Our Ref: 20180C.12RP_RFI Response Letter

**RE: SSD-10291 PROPOSED SENIOR SCHOOL CAMPUS AND SPORTS CENTRE
ST LUKES GRAMMAR SCHOOL
210 HEADLAND ROAD AND 800 PITTWATER ROAD DEE WHY AND 224
HEADLAND ROAD, NORTH CURL CURL**

Table 1: Responses to TfNSW Letter dated 16 November 2021

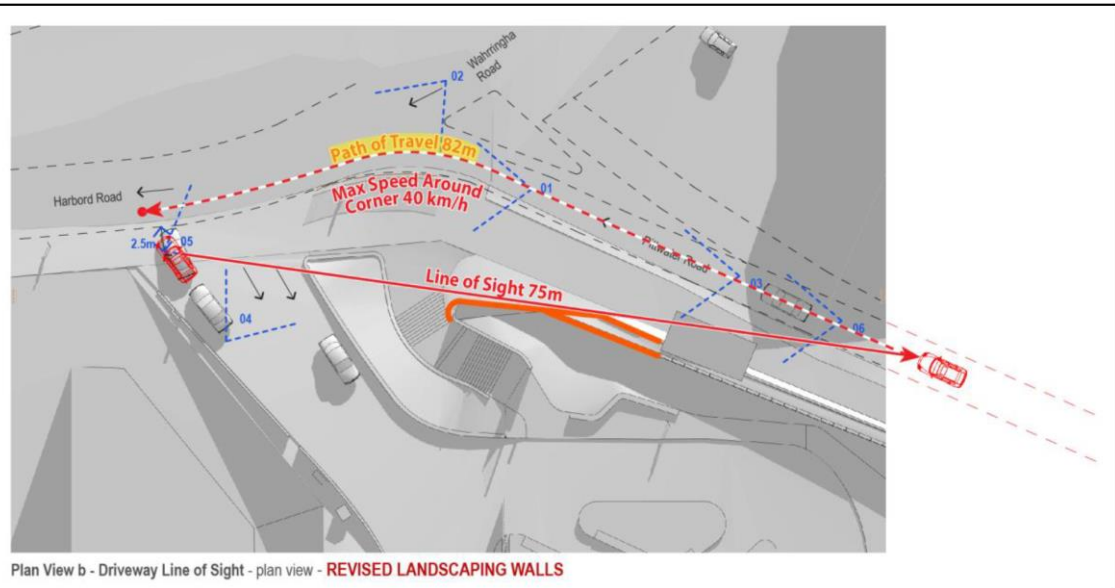
Matter Raised by TfNSW	Response
	It is noted that no significant change is proposed to the location or dimensions of the existing vehicle access to Harbord Road and therefore there will be no reduction in the manoeuvrability of vehicles into and out of the site. It is therefore considered that the proposed redevelopment and use of the site as an educational establishment for senior school students (Years 10 – 12) will not have an adverse impact on the safety of pedestrians or motorists.
<i>In accordance with AGRD Part 4A. Sight distances at accesses should comply with the sight distance requirements for intersections, i.e. that approach sight distance (ASD), safe intersection sight distance (SISD), and minimum gap sight distance (MGSD) are to be achieved. Therefore, the current driveway location and alignment does not meet relevant Austroads and Australian Standards and is unsuitable as an access/egress point.</i>	Sight distances have not previously been raised by TfNSW or Council however an additional plan was provided as part of the RTS package (Plan Rev RTS-013) which provided sight lines for traffic and pedestrians, having regard to the proposed pedestrian fence (Attachment 4). The plan indicates that there will be little to no impediment to the lines of sight for drivers (Figure 1). At Stage 1 the landscaping in this area of the site will be significantly reduced. At Stage 2 and Stage 3 the new entry stairs and landscaping will maintain the pulled-back terracing of the landscaping and will not introduce new shrubs into this part of the site (as detailed in the Architectural Plans). Amendments have been made to the front landscaping walls to minimise visual obstructions. To assist in the further assessment of this matter, TZG Architects has prepared six (6) driveway line of sight view plans which show the differences in the lines of sight achieved between the original SSDA proposal and the amended landscaping walls at the front entry of the site (refer Attachment 4). The sight distances at the site access are considered generous and in excess of the requirements of the relevant Austroads and Australian Standards, and will provide a safe and unimpeded view line of vehicles entering Harbord Road from Warringah Road (from west to south) and from Pittwater Road (from north to south via the turning lane). Varga Traffic Planning has provided a response to the TfNSW issue of sight distances at the site access (refer Attachment 2) commenting as follows: <i>“The layout of the existing vehicular access driveway off Harbord Road and 16m width (ie. two entry lanes and one exit lane) is proposed to be retained and changed.</i> <i>However, the existing landscaping and embankments located to the north of the driveway are proposed to be cut back. This will provide an improved line of site between a vehicle exiting the site and a southbound vehicle turning left from Pittwater Road into Harbord Road, as indicated on the diagram below.”</i> (refer Figure 1 and Attachment 4)

Matter Raised by TfNSW	Response
	 Figure 1 Proposed driveway lines of sight Under the Austroads publication Guide to Road Design Part 4a (2021), there are three (3) types of sight distances as follows: • Approach sight distance (ASD) is the sight distance which must be available on the minor road approaches (in this instance, the exit driveway) to all intersections to ensure that drivers are aware of the presence of an intersection. • Safe Intersection Sight Distance (SISD) is the minimum sight distance which should be provided on the major road at any intersection, and is measured along the road carriageway path of travel. • Minimum Gap Sight Distance (MGSD) is the minimum sight distance required at property entrances and is also measured along the path of travel of the approaching vehicle. The following table extracted from the Varga Traffic Planning report provides a comparison between the minimum sight distance requirements and the proposed sight distances (Figure 2). It is noted that the maximum speed of left-turn movements from Pittwater Road into Harbord Road is constrained by the existing road geometry to less than 40km/h; a 40km/hour School zone Speed Limit is anticipated in the vicinity of the driveway during school zone times which is when the majority of traffic generation is anticipated to occur; and peak hour speeds through the intersection are generally less than 40km/hour.

Varga Traffic Planning has demonstrated that the driver sight distance diagram complies with the Austroads minimum gap sight distance (MGSD) requirement of 55metres, by having a MGSD of 82 metres (**Figure 1**).

Figure 3 Proposed pick up and drop-off arrangements (Stage 3) (Varga Traffic Planning)

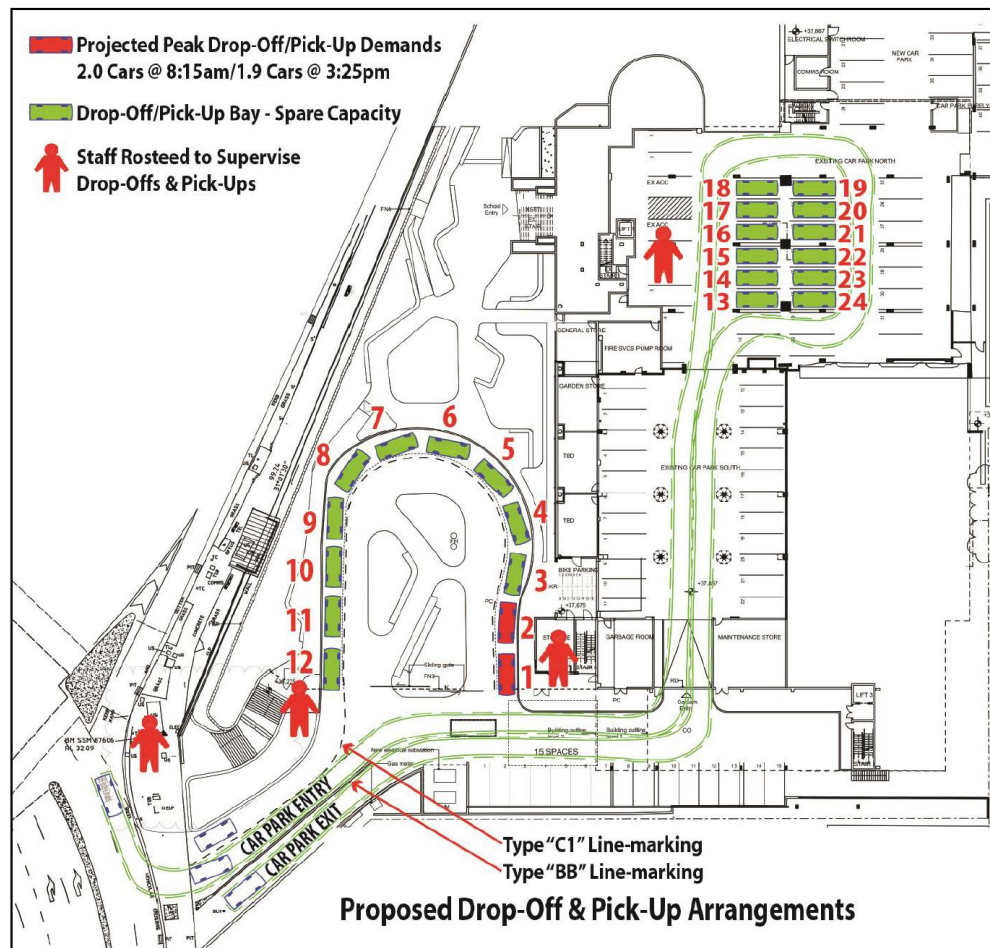
Matter Raised by TfNSW	Response
	Varga Traffic Planning have provided a response in respect to the drop-off and pick-up arrangements for the proposed Senior School campus (refer Attachment 3) and comment as follows: <i>“Under the Traffic Management Plan which forms part of the Development Consent for the existing school, the school is required to provide up to 12 staff to supervise the drop-off and pick-off arrangements.</i> <i>A similar Traffic Management Plan is proposed for the Senior School which will require up to 4 staff to supervise drop-offs and pick-ups at the new Senior School campus as illustrated on the figure below (Figure 3).</i> <i>In particular, one of those staff will be located at the top of the main entry driveway near space 12, who will direct traffic into the basement car parking area in the unlikely event that the first 12 spaces in the external are full. Two other staff will supervise drop-offs and pick-ups whilst the fourth staff member will supervise students at the bottom of the stairs near the signalised pedestrian crossing (where a pedestrian safety fence is proposed).</i> <i>In addition, it is noted that the 12 drop-off / pick-up spaces proposed within the basement car parking area will be located approximately 170m from the site entry off Harbord Road.</i> <i>Thus, there is no foreseeable possibility that a “small percentage” of cars could queue back onto Harbord Road.”</i> The proposed pick-up and drop-off arrangement will have a capacity of 24 vehicles (12 vehicles within the forecourt and a further 12 spaces within the basement carpark). The 12 pick-up and drop-off spaces located within the basement are located approximately 170m from the vehicle entry on Harbord Road. The 170m length of the driveway from the vehicle entry on Harbord Road will conservatively enable a queuing area for at least 20 vehicles.

Figure 1: Crash Location Map (30 January 2017 and 7 February 2020)

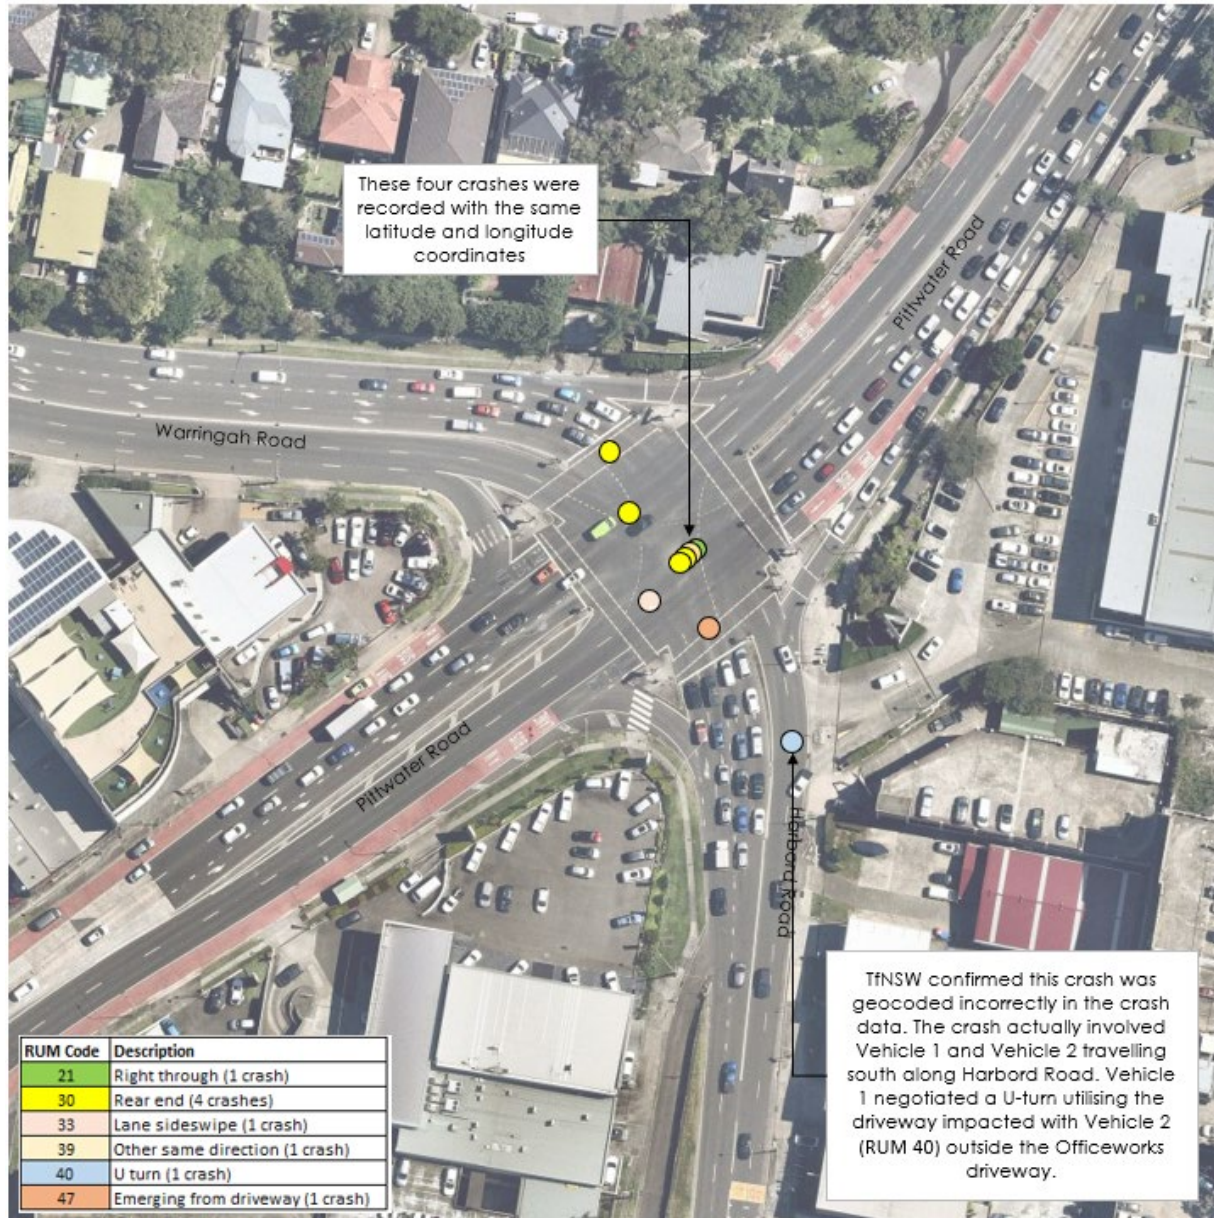
The location and Road User Movement (RUM) type of the crashes are shown in Figure 1. Crash locations are based on the latitude and longitude coordinates provided in the TfNSW Interactive Crash Statistics, referencing to the Crash ID recorded in the TfNSW Detailed Crash Report and Summary Crash Report. The only exception is the crash (ID 1164104) that occurred on Harbord Road as the description in the Detailed Crash Report and the latitude and longitude coordinates did not match. Consultation with TfNSW's crash data team has confirmed that the latitude and longitude coordinates are incorrect and the crash actually occurred on Harbord Road southbound outside the Officeworks driveway.

- One crash (11%) involved a vehicle emerging from the Officeworks driveway (RUM 47) onto the intersection and hit a cyclist. Based on the crash location, it is believed that the motorist illegally turned right from the driveway towards the intersection and hit the cyclist travelling northbound on Harbord Road. This crash event occurred in the morning peak hour between 8am and 9am.

- One crash (11%) involved a motorist making a U-turn movement at the Officeworks driveway (RUM 40) and collided with a vehicle travelling along Harbord Road southbound.

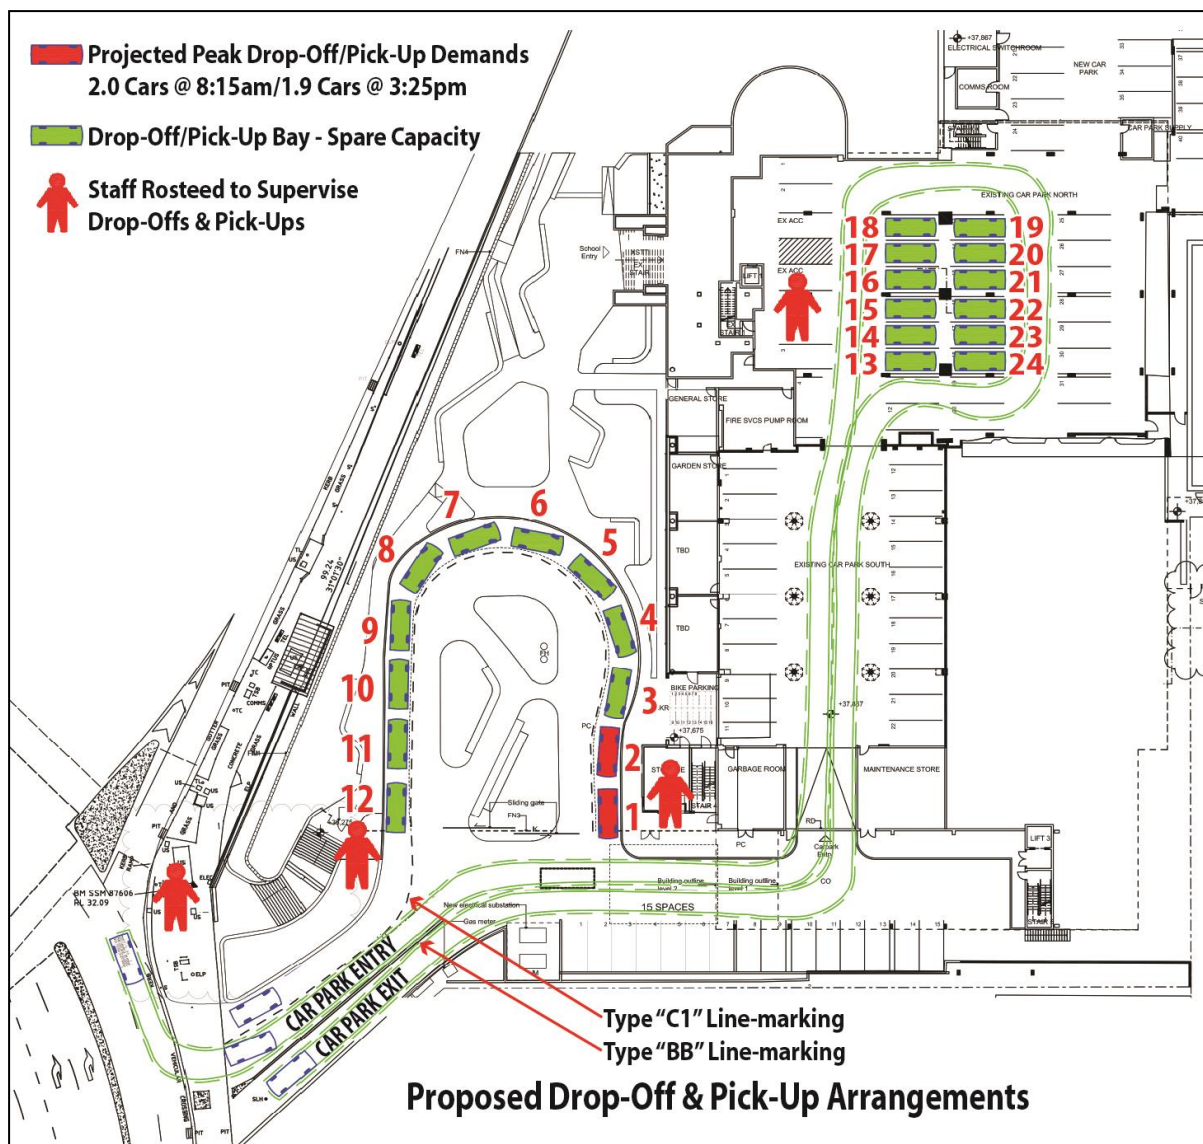
However, the existing landscaping and embankments located to the north of the driveway are proposed to be cut back. This will provide an improved line of sight between a vehicle exiting the site and a southbound vehicle turning left from Pittwater Road into Harbord Road, as indicated on the diagram below.

In summary, all of the *sight distance* criteria nominated by Austroads will be satisfied by the proposed development. It is noted also in this regard that the *TTPP* report found that:

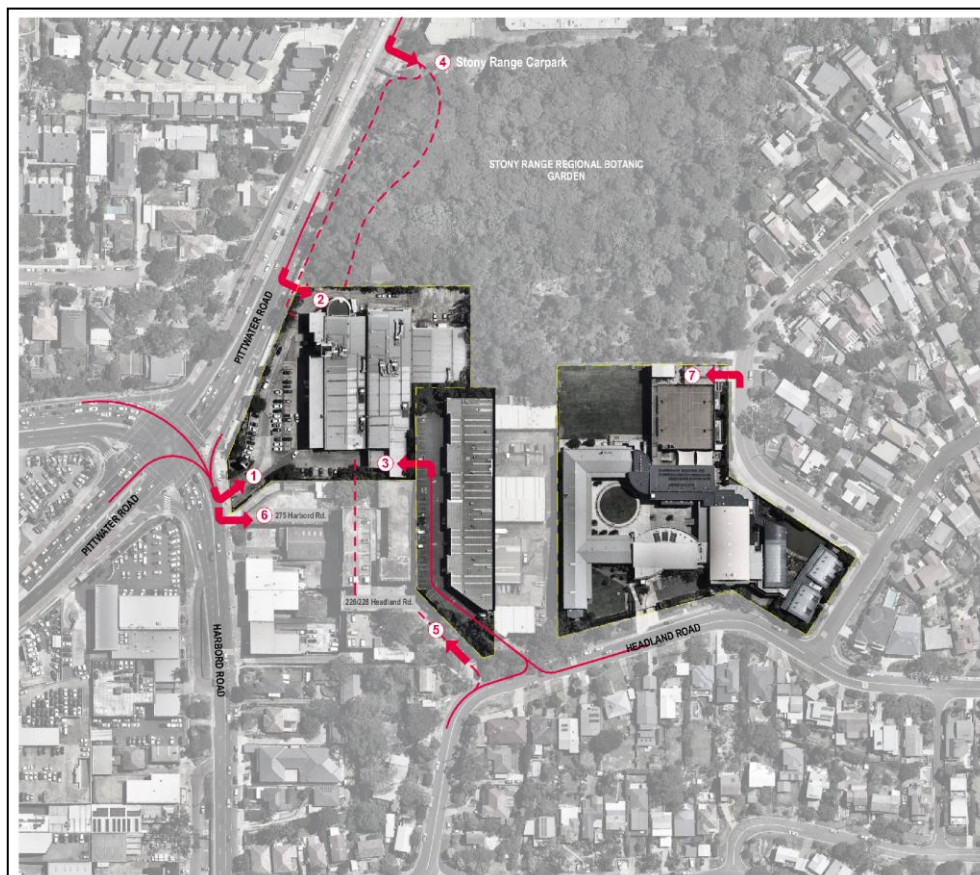
A similar *Traffic Management Plan* is proposed for the *Senior School* which will require up to 4 staff to supervise drop-offs and pick-ups at the new *Senior School* campus as illustrated on the figure below.

In addition, it is noted that the 12 drop-off/pick-up spaces proposed within the basement car parking area will be located approximately **170m** from the site entry off Harbord Road.

Thus, there is no foreseeable possibility that a “small percentage” of cars could queue back onto Harbord Road.

Plan View b - Driveway Line of Sight - plan view - **REVISED LANDSCAPING WALLS**

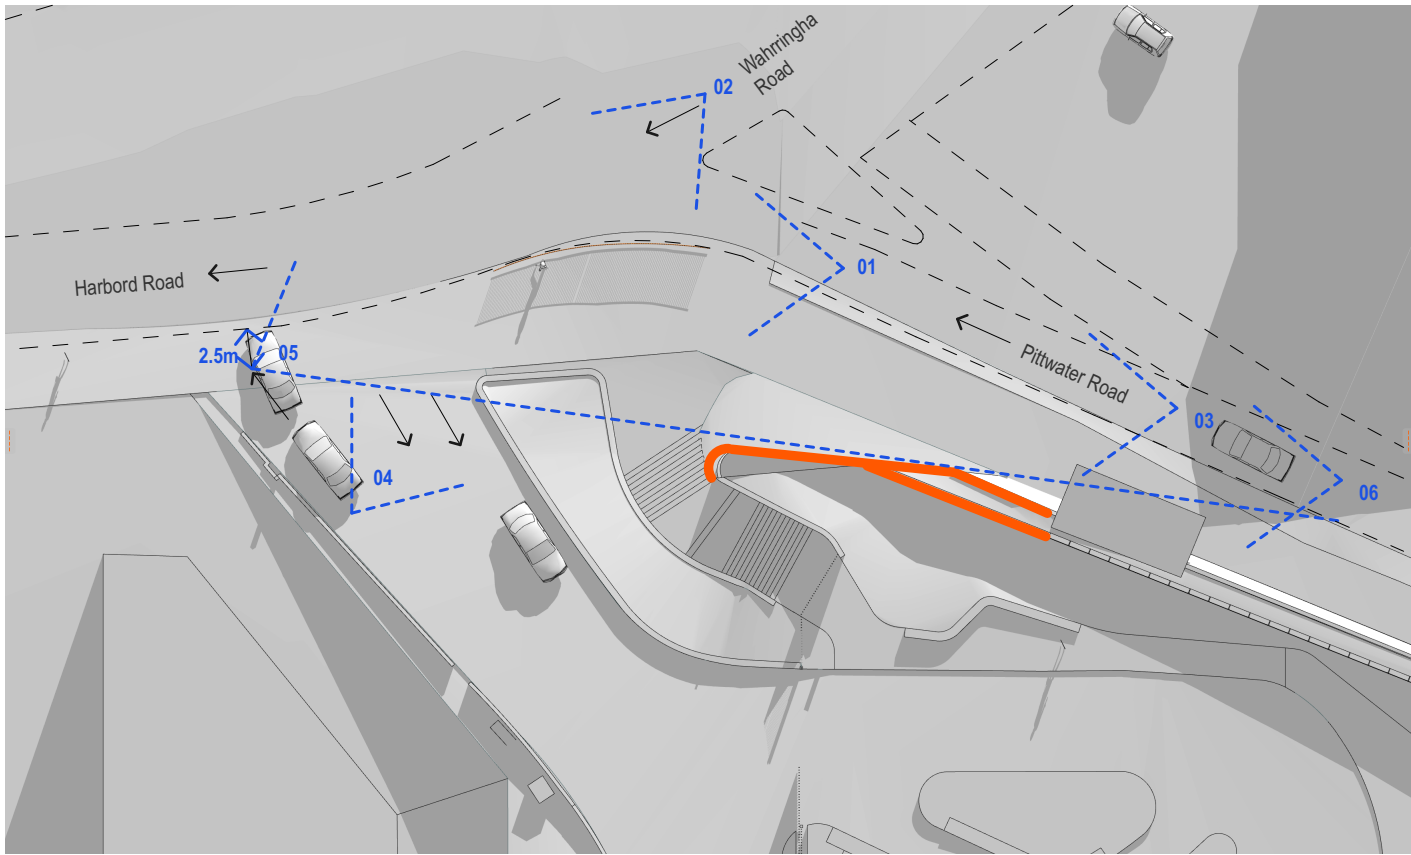
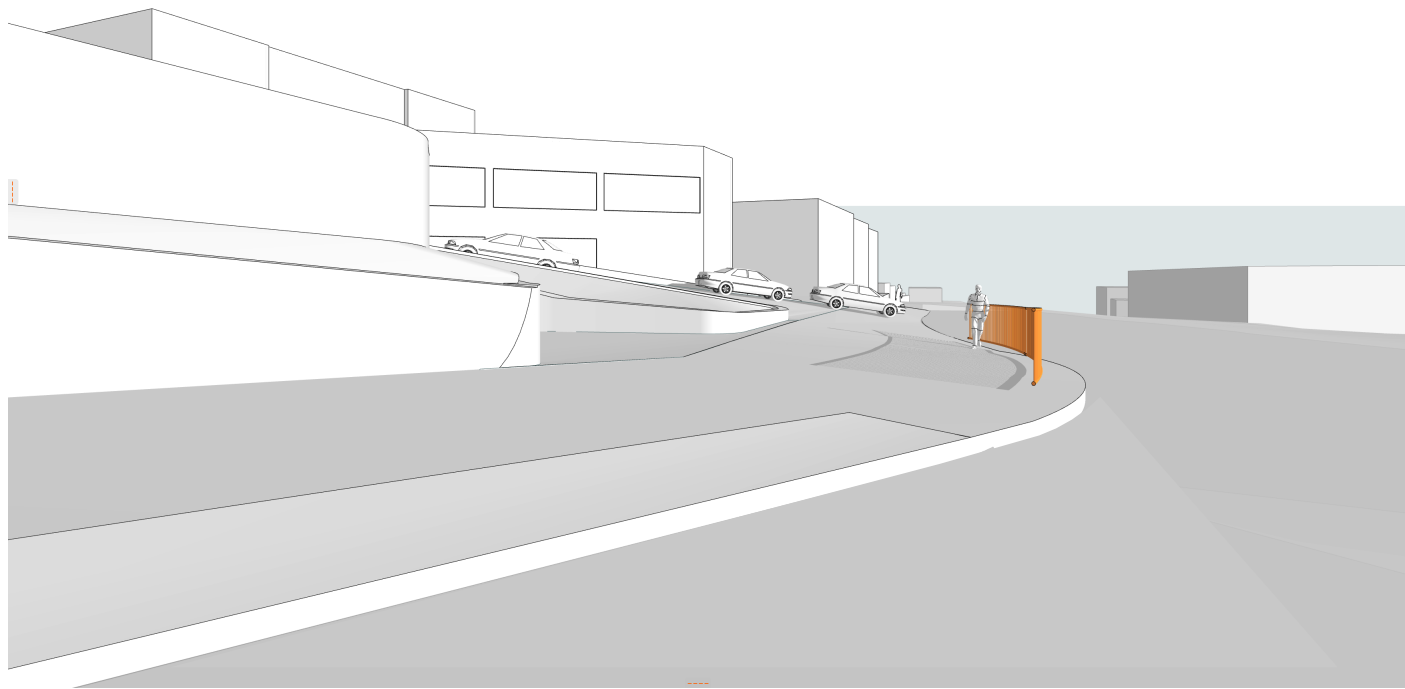
To assist in the further assessment of this matter, TZG Architects has prepared driveway line of sight view plans which show the differences in the lines of sight achieved between the original SSDA proposal and the amended landscaping walls at the front entry of the site (refer Attachment 1).

Therefore, the sight distances at the site access are considered generous and in excess of the requirements of the relevant Austroads and Australian Standards and will provide a safe and unimpeded view line of vehicles entering Harbord Road from Warringah Road (from west to south) and from Pittwater Road (from north to south via the turning lane).
